Subject: Comment Letter – Basin Plan Amendment to Add Electrical Conductivity Water Quality Objectives in the San Joaquin River Between the Mouth of the Merced River and the Airport Way Bridge near Vernalis

## Technical Report

### **Comment Letter – Basin Plan Amendment to Add Electrical Conductivity Water Quality Objectives in the San Joaquin River Between the Mouth of the Merced River and the Airport Way Bridge near Vernalis**

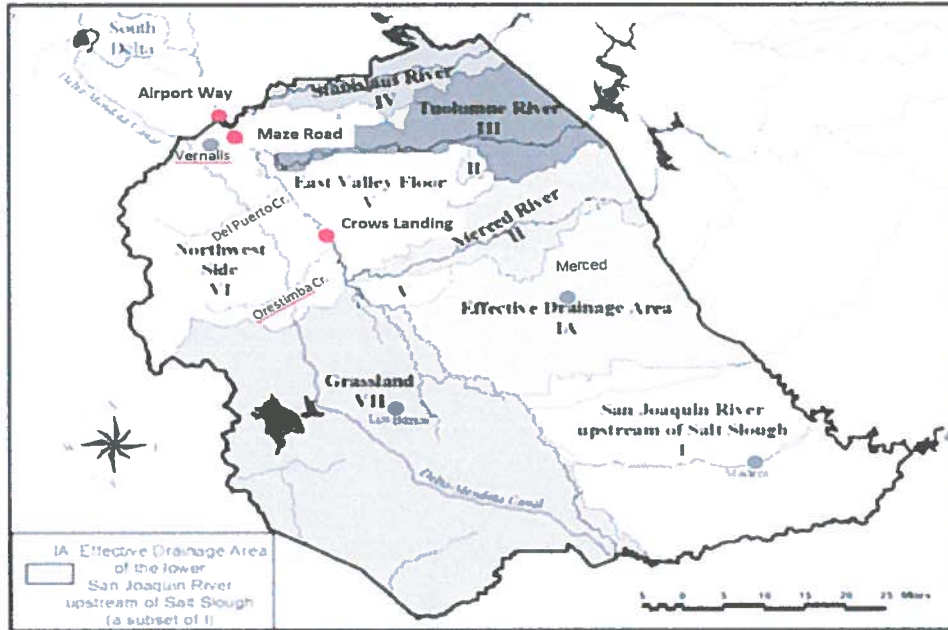
Reclamation’s concern is that an EC of 1550 uS/cm, or higher, at Maze Road Bridge (which is approximately 3 miles from the Vernalis compliance point) creates a new dilution demand at Vernalis, which has a standard of 700/1000 uS/cm. The dilution demand is further increased if the EC at Maze Road Bridge is allowed to reach 2470 uS/cm during Extended Dry Periods. It is important to consider that there are no allowances for Extended Dry Periods for the standards at Vernalis.

Figure 2. Relative Almond Crop yield

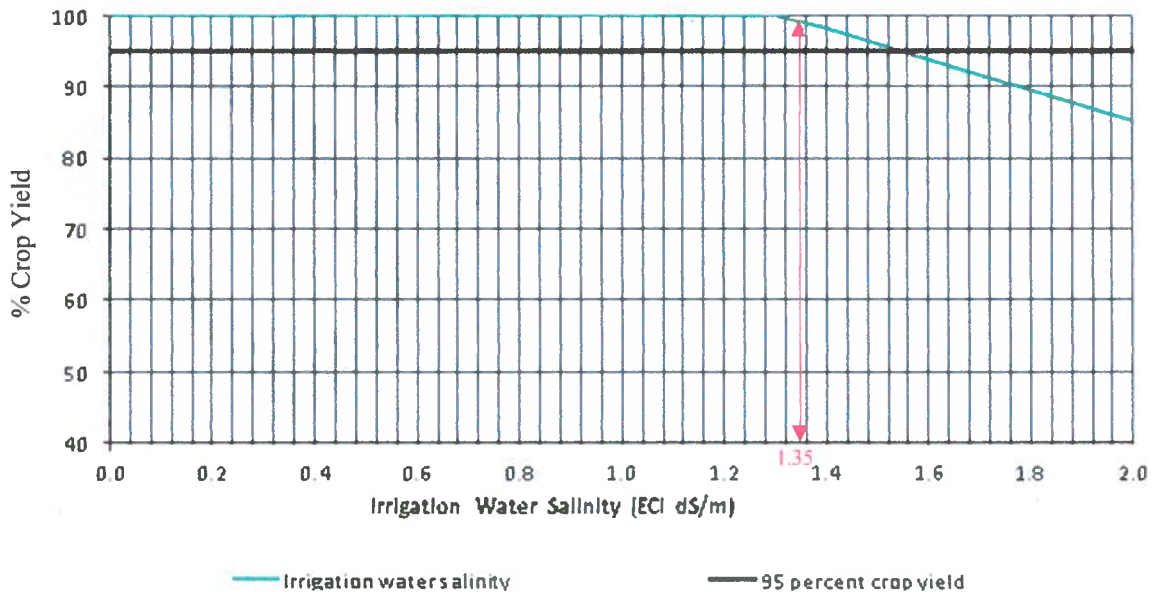
Data demonstrates that the section of the river between the Tuolumne River and the Stanislaus River is capable of complying with an objective of 1350 uS/cm during Extended Dry Periods. An objective of 1350 uS/cm during Extended Dry Periods would be protective of an approximately 98% almond yield as shown in Figure 2.

Figure 3. Graph showing that 100% of existing data is less than 1250 uS/cm during non-extended dry periods.

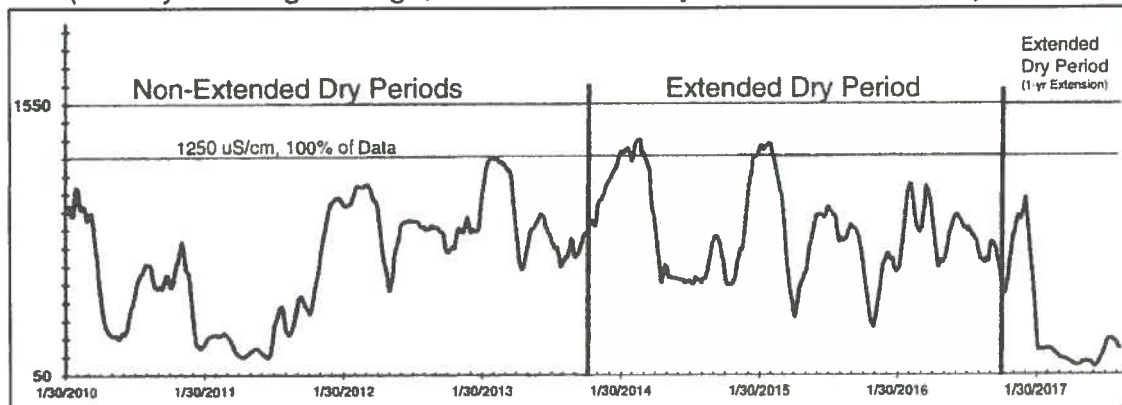
available from CDEC shows that the water quality in the section between the Tuolumne River and the Stanislaus River is capable of meeting a primary EC objective of 1250 uS/cm, which is protective of 100% of the almond crop yield. That data also shows that between January 2010 and September 2017, the highest annual average EC was 920 uS/cm. Therefore, an objective for annual average EC should be at, or near, 920 uS/cm.

Figures 3 and 4 show that the existing data is usually compatible with a WQO set at 1250 uS/cm, and at 1350 uS/cm during extended dry periods.
